Agenda Item # 3 BOA-002773-2023

1704 McGill Avenue

- Use, Access, and Parking Surface Variances to allow a duplex on a lot with sub-standard access and aggregate parking surface for a duplex in an R-1, Single-Family Residential Urban District.

SITE PLAN

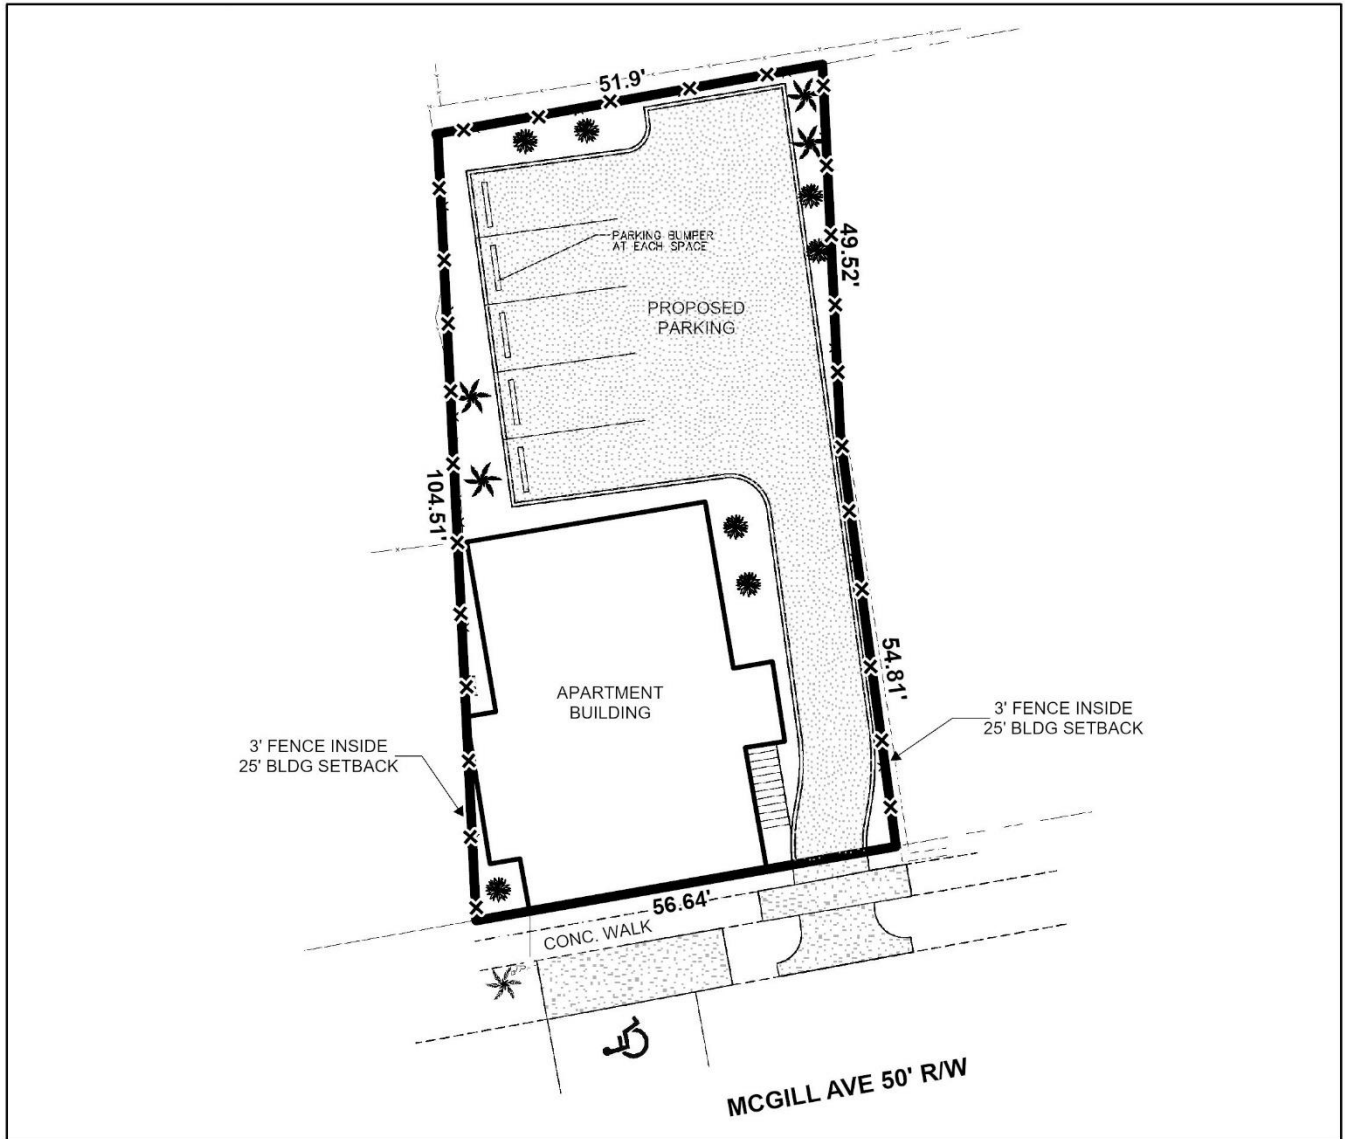
Providing the marked on-street parking does not allow for enough roadway width for two-way travel. For two-way travel two lanes are required and each lane shall be at least ten feet wide on residential streets. The roadway will need to maintain a total width of twenty feet. Although on-street parking is allowed on residential streets it is not marked and not reserved for any particular property. Traffic Engineering does not approve marked on-street parking on residential streets. Driveway number, size, location, and design to be approved by Traffic Engineering and conform to AASHTO standards. Any required on-site parking, including ADA handicap spaces, shall meet the minimum standards as defined in Article 3, Section 64-3-12 of the City's Unified Development Code.

The UDC requires all properties with two-way access to provide a driveway that is 24 feet wide. The site plan submitted illustrates a driveway that is 10 feet wide.
